Access Compliance Report

Public Rights-of-Way

Intersection ID: 14235	Main Street: CAMDEN_RD	Cross Street: E_TREMONT_AV	Location: SW
ADA ID: 00F55ECA0F0E	Ramp Type: Perp	Initial Pass/Fail: Fail	Overall Compliance: No
			Severity Score: 21.25

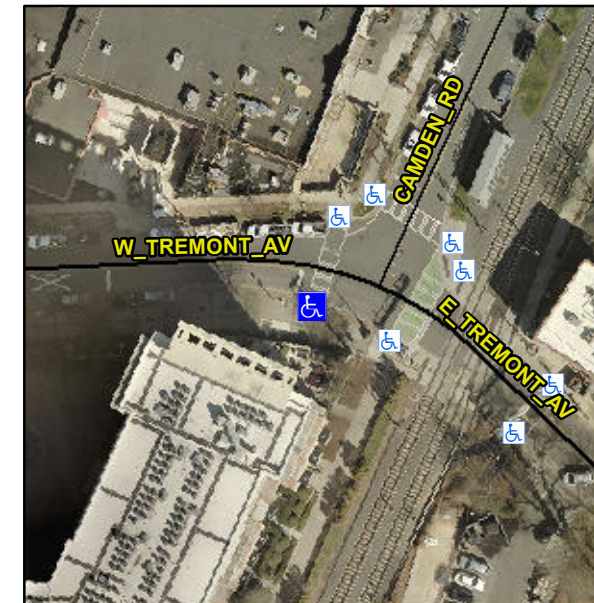
R304.5.1, R304.2.2

Compliance	Description	Data	Compliance	Description	Data
N/A	Ramp Length (in)	71.0	No	Ramp Slope (%)	8.6
No	Ramp Width (in)	47.0	Yes	Ramp XSlope (%)	1.7
N/A	Flare Type LT	N/A	N/A	Flare Type RT	N/A
N/A	Flare Slope LT (%)	N/A	N/A	Flare Slope RT (%)	N/A
N/A	Flare Traversable LT?	N/A	N/A	Flare Traversable RT?	N/A
N/A	Landing Length (in)	N/A	N/A	DWS Provided?	N/A
N/A	Landing Width (in)	N/A	N/A	DWS Contrast?	N/A
N/A	Landing Slope (%)	N/A	N/A	DWS Length (in)	N/A
N/A	Landing X Slope (%)	N/A	N/A	DWS Full Width?	N/A
N/A	Landing Curb? (Y/N)	N/A	N/A	DWS Offset (in)	N/A
N/A	Shared Landing?	N/A			
N/A	Gutter Ponding?	N/A	N/A	Gutter Slope (%)	N/A
N/A	Gutter Lip Ht (in)	N/A	N/A	Gutter X Slope (%)	N/A
N/A	Painted X Walk1?	Yes	N/A	Painted X Walk2?	N/A
	X Walk 1 Direction	To NE		X Walk 2 Direction	N/A
N/A	X Walk 1 Width (in)	102.0	N/A	X Walk 2 Width (in)	N/A
	X Walk 1 Slope (%)	1.2		X Walk 2 Slope (%)	N/A
	X Walk 1 X Slope (%)	1.6		X Walk 2 X Slope (%)	N/A

Remove & Replace Entire Ramp.
